# City Planning Department

To: Cranston City Plan Commission  
From: Joshua Berry, AICP - Senior Planner / Administrative Officer  
Date: July 30, 2021  
Re: **Dimensional Variance @ 173 Niantic Avenue**

**Owner:** Frank Zincone  
**Applicant:** Ercilio Tejada  
**Location:** 173 Niantic Avenue, AP 7, Lot 2204  
**Zone:** M-2 (General Industry)  
**FLU:** Industrial

# SITE PLAN

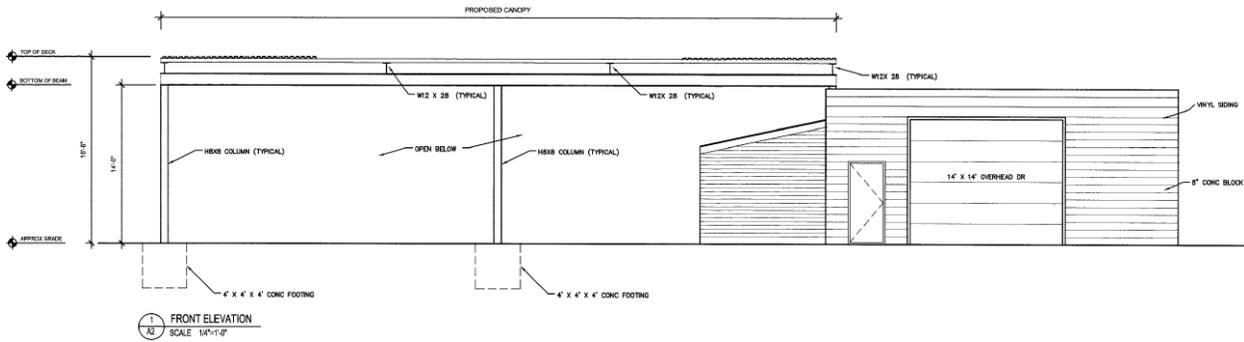
- The canopy addition would be 0' from the "front" property line on Dewey Street, which has a 40' front yard setback and 8.3' from the southern interior side lot line which has a 20' setback in M-2 zoning.

- The steel beams for the canopy were erected without benefit of a permit. A portion of the beams were in the right-of-way of Dewey Street and will need to be relocated to the location shown on the site plan.

- The canopy is proposed to be 16' 6" high. The building is 14' high. Both comply with the 35' height limitation.
- The site plan shows 6 spaces, which meets the City's off-street parking requirements for industrial uses.

- 1. The signage shall be brought into compliance with city code; and*
- 2. The parking shall be striped as shown on the site plan titled "Open Canopy Design – Ercilio's Electro Auto" by Manoukan Architect dated 7/20/21 or as on a plan to be reviewed and approved by the City's Traffic Safety Bureau.*
